TECHNICAL CONFERENCE UNDERTAKING RESPONSES TO SCHOOL ENERGY COALITION

JT1.8

TECHNICAL CONFERENCE UNDERTAKING RESPONSES TO VULNERABLE ENERGY CONSUMERS COALITION

INTERROGATORY RESPONSES TO VULNERABLE ENERGY CONSUMERS COALITION

Figure 1 - Updated Figure A in MW Actuals, weather corrected, and forecast(s) in MW

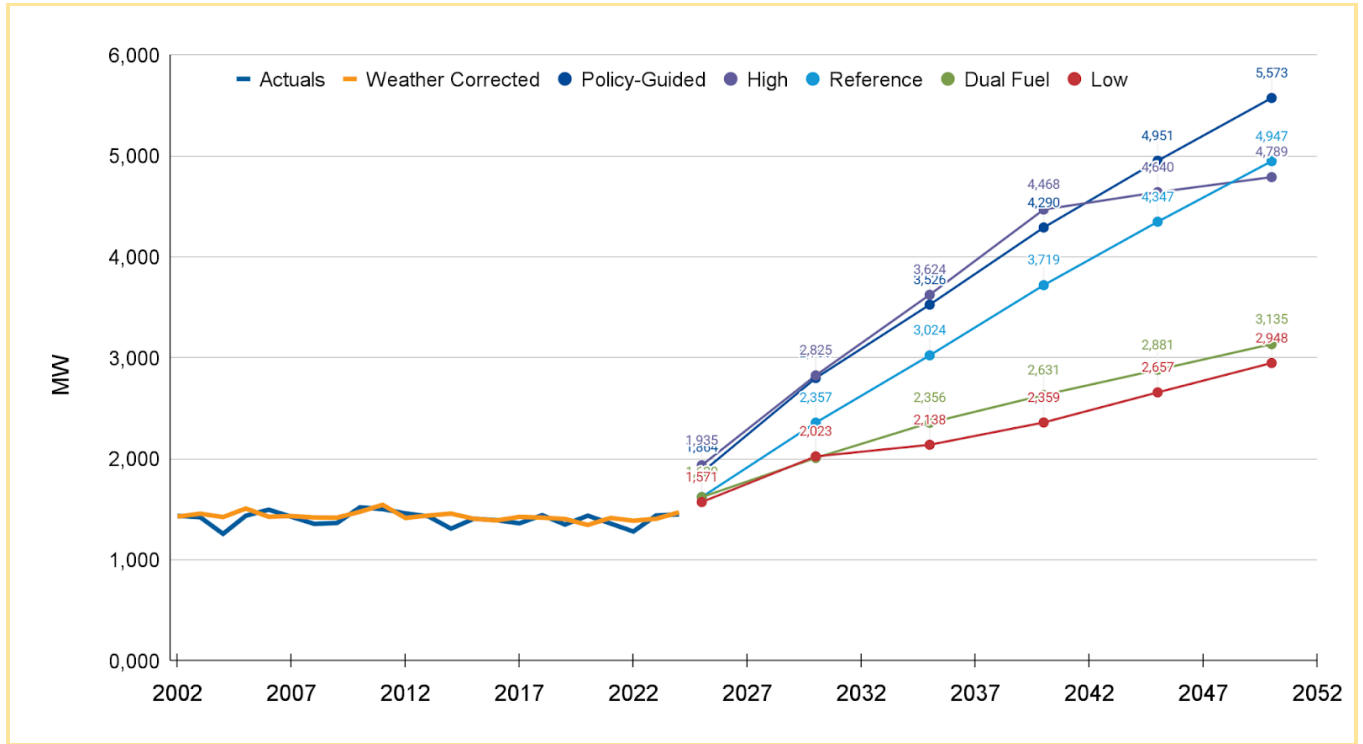
To provide the figure a from 2-Staff-72 in the tabular format, and to clarify whether the actuals and weather-corrected information actually provided in MVA instead of megawatts; and if not, is there a power conversion that was used.

Figure A in the initial interrogatory response 2-Staff-72 ~~was initially given with actuals and weather corrected values in MVA, whereas the forecasts were given in MW~~ provided actuals and weather corrected values in MW but were incorrectly labeled as MVA. The forecast values were consistently in MW. During the preparation of the original Undertaking JT1.8, a factor of 0.9 was incorrectly applied as a multiplier to both the actual and weather-corrected MW values. ~~Tables A and B below provide actuals and weather corrected values in MW, using a standard power factor of 0.9, along with the decarbonization scenario forecasts in MW.~~ Table A, Table B and Figure 1 have been revised to present actual and weather-corrected peak MW values. Note that the system peak provided within Tables A and B for the decarbonization scenarios is the higher value of either the summer or winter peak. The information presented is derived from the summation of loading at each transmission connected station to represent the system level peak.

Figure 1, provides an update to the reference Figure A from response to interrogatory 2-Staff-72 including 2024 actuals and all values in MW provides the graphical representation of the data provided in Table A and Table B.

Figure A – Cumulative (MVA) Large Load Requests

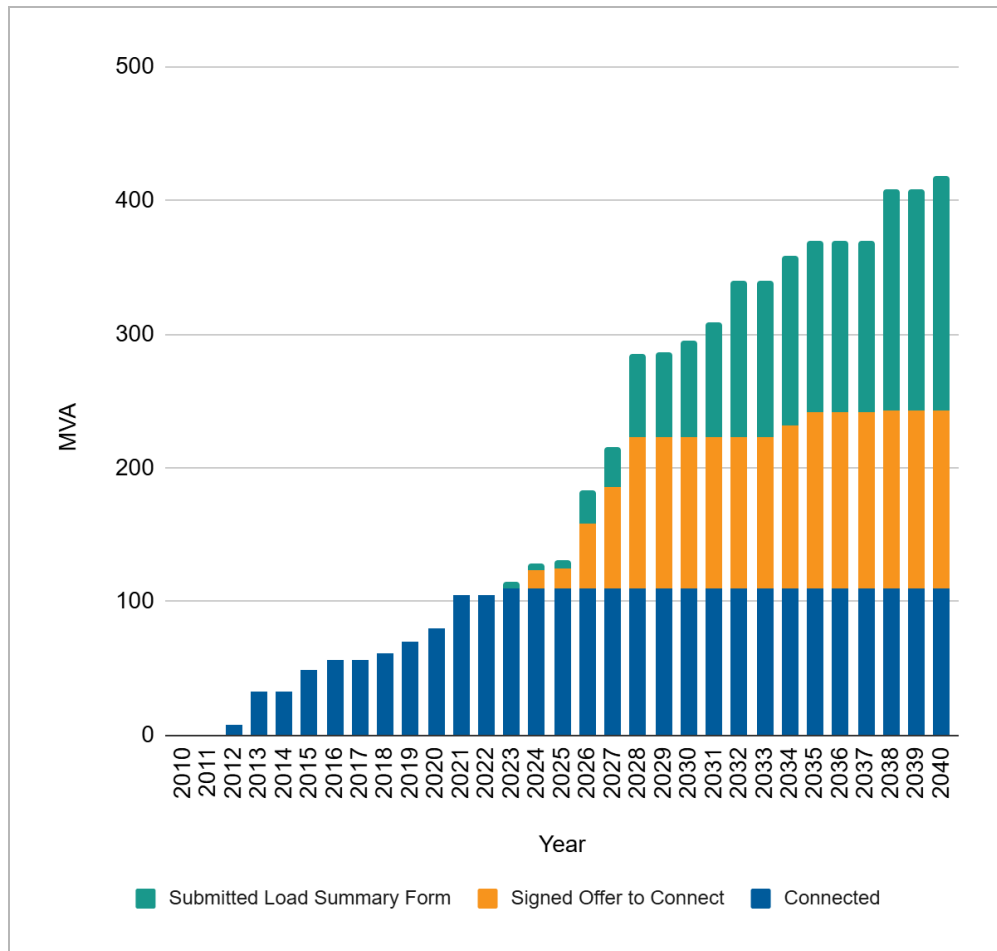
i. Please provide a revised version of Figure 1 (Exhibit 1-3-1, page 2) that reflects the load requests incorporated in the 2026-2030 load forecast.

i) Please refer to Figure A below for a revised version of Figure 1 from Exhibit 1-3-1 - Rate Setting Framework that reflects the load requests incorporated in the 2026-2030 planning load forecast.
